*Cooling Water Alternatives
ESSA review*

October 3, 2002

**Millstone Power Station
Cooling-Water System Technology Study
Response to DEP Comments**

RESPONSES TO QUESTIONS, COMMENTS, AND CONCERNS REGARDING THE
AUGUST 31, 2001 REPORT "MILLSTONE POWER STATION AN EVALUATION OF
COOLING-WATER SYSTEM ALTERNATIVES" AS NOTED IN THE LETTER OF MAY 9,
2002 FROM J. GRIER, CT DEP, TO DOMINION NUCLEAR CONNECTICUT, INC.

Fig. 2/3.5-1. Location of the former MPS three-unit thermal plume isotherms (1.5°F, 4°F, 6°F, and 8°F) at maximum flood and high slack tides (from NUSCO 1988).

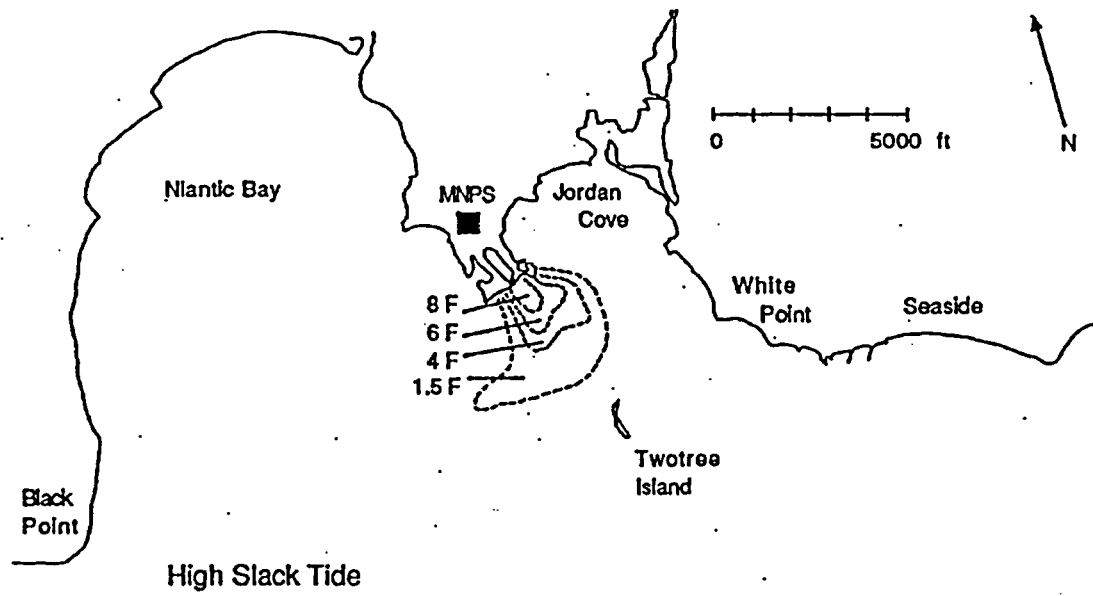
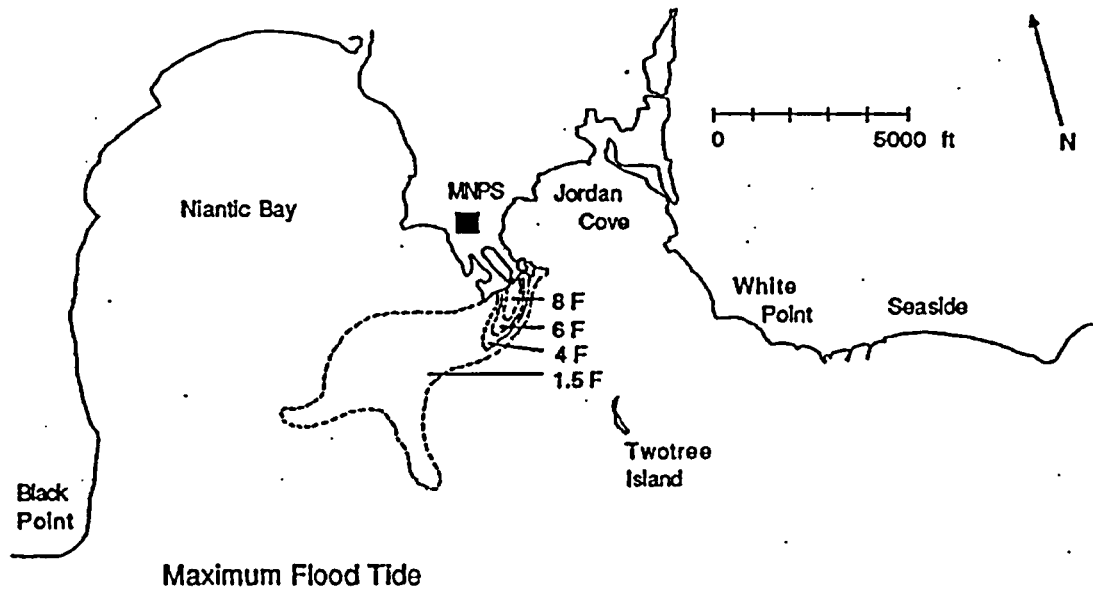
Guidelines for the zone of passage for aquatic organisms in DEP (1992) are given as no more than 25% of the cross-sectional area or volume of flow. The MPS thermal discharge for Units 2-3 at present and for the reduced flow options presented in this document would not impede a zone of passage for free swimming and drifting organisms. The largest volume discharge for the new options presented is 1,631,000 gpm for a 10% increase in present cooling-water flow during the summer and early fall. This total is only 3% of the average tidal flow of 54 million gpm through Twotree Island Channel and 0.1% of the maximum tidal flow. The present two-unit thermal plume and plumes for the reduced flow options and the 10% increased flow alternative are or would be smaller in surface area and volume than the thermal plumes from former three-unit MPS operation at four tidal stages shown in Figures 2/3.5-1 and 2/3.5-2.

Figure 6.1-2: Millstone Unit 2 - Electric Generation Rate Change vs Variable Speed CWP's and Inlet Temperature

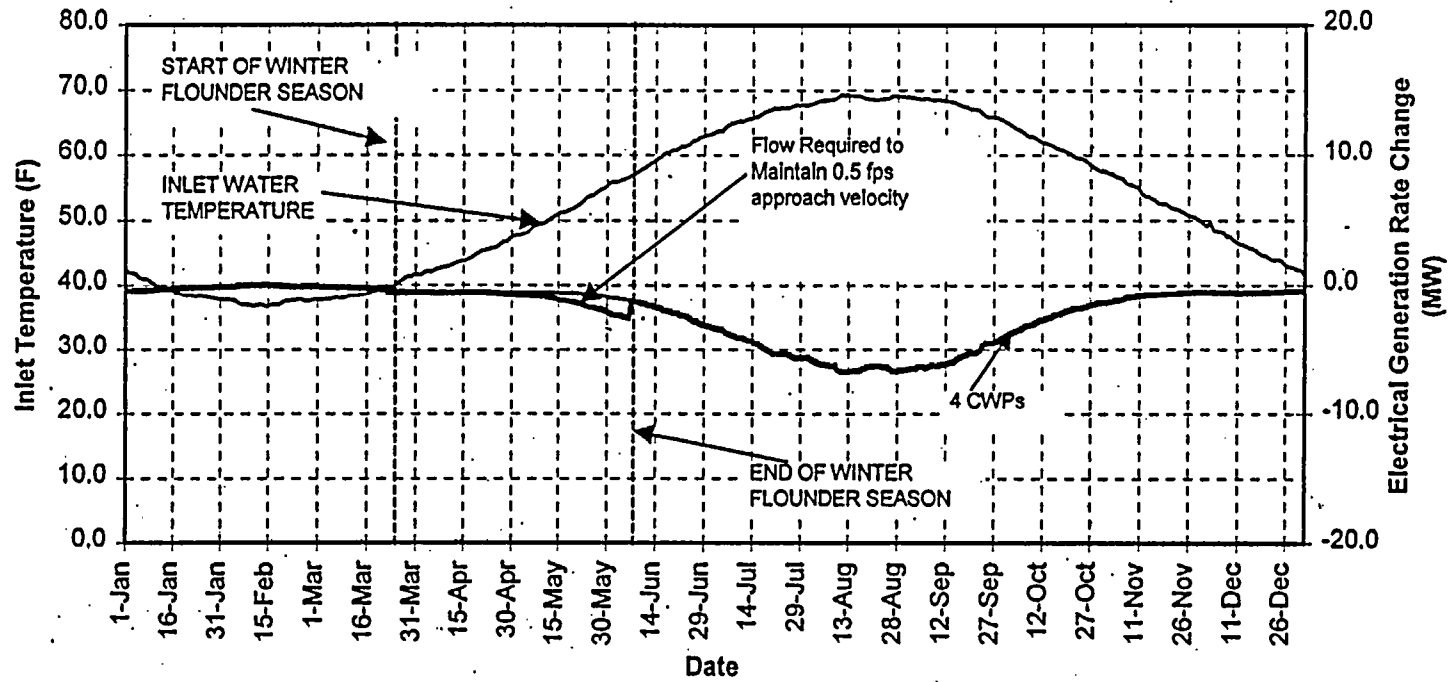
In our opinion there are, as shown in the study, several alternatives by which DNC can reduce intake flows (e.g. new variable speed pumps, throttling of existing pumps, bypass, or re-circulation concepts, etc.) which, especially in combination with a potentially higher permitted delta T, could result in a significant reduced Station inflow and entrainment losses. The Department does not agree that the cost of these modifications is prohibitive. Some, in fact, (such as more efficient variable speed condenser circulation pumps) may serve to satisfy ongoing Station O&M needs and have attractive life-cycle payback costs.

Figure 6.1-2 shows the relationship, for Unit 2, between the change in electrical generation rates for all CWPs operating and the reduced flow rate for the combined Units 1 and 2 intakes during the larval winter flounder entrainment season.

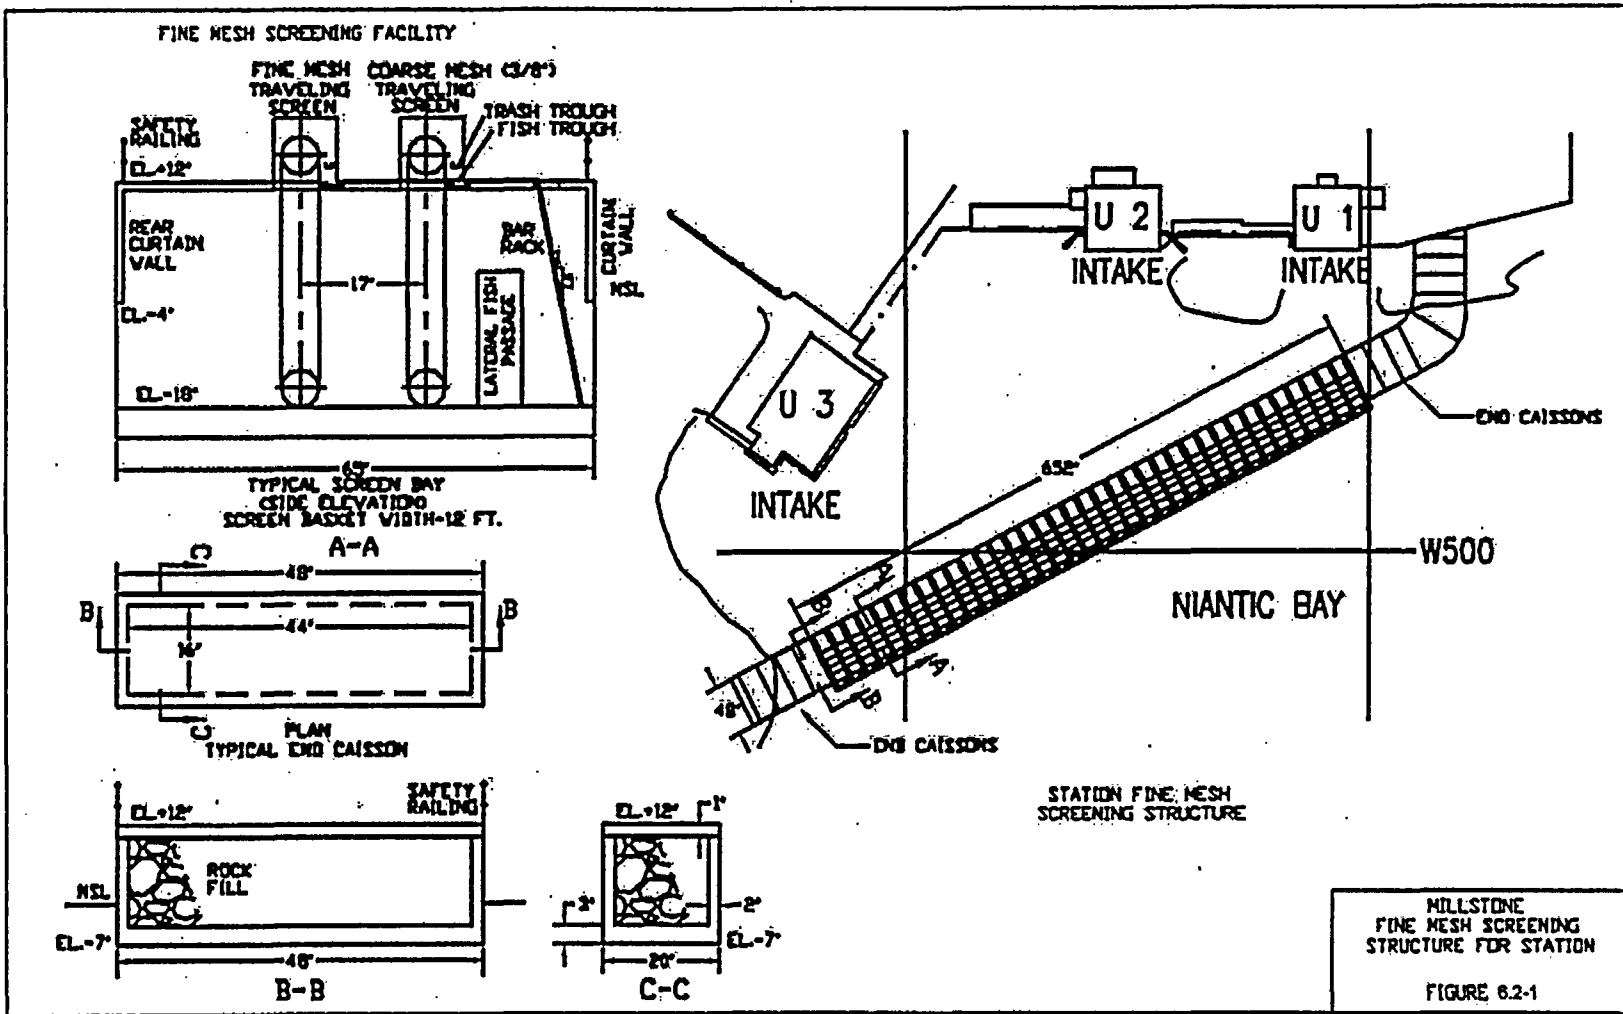
While recognizing that DNC has already responded at some length on this matter (i.e. its 2/26/02 response), ESSA is still of the opinion that the alternative of constructing effectively designed and positioned shoreline structures such as groins or jetties may have merit and deserves further consideration. At a minimum, a nearshore hydrographic modeling study of the effects of such a structure on current patterns in front of and adjacent to intakes should be conducted.

The preliminary design for the fine-mesh screen structure is shown on Figure 6.2-1. This design consists of constructing an entirely new through-flow screening structure across the embayment in which the MPS intakes are located. This alternative would completely isolate the existing MPS intakes from Niantic Bay. The structure consists of 36 reinforced concrete screening bays with end structures, which connect both ends of the screen structure to the shore. The end structures consist of concrete caissons filled with stone rubble for ballast. Access roads are provided on top of both end structures to provide access to the screen structure for cranes and other maintenance equipment. The entire screen structure is founded on a tremie concrete mat placed on the sea bottom. Each screen bay contains curtain walls on both upstream and downstream ends, coarse bar racks, a coarse mesh traveling screen equipped with both adult fish removal features and heavy debris handling features, and a fine-mesh traveling screen for capture, removal, and return of fish larvae and eggs. The screen structure would be equipped with two traveling rake systems to clean the trash racks.

Two fish removal sluicing systems would be provided to transport larger fish and the ichthyoplankton removed from the coarse- and fine-mesh screens, respectively, back to Niantic Bay. One sluice services the south half of the screening structure and one serves the north half of the structure. The actual locations for returning eggs, larvae, and fish would be established after additional studies have been completed, should this alternative be selected. The sluicing systems would be similar in design concept to the existing sluicing system for the Unit 3 intake, although larger in capacity. A lateral fish passageway would be provided in the structure between the trash racks and the coarse-mesh traveling screens to allow escapement of adult fish.
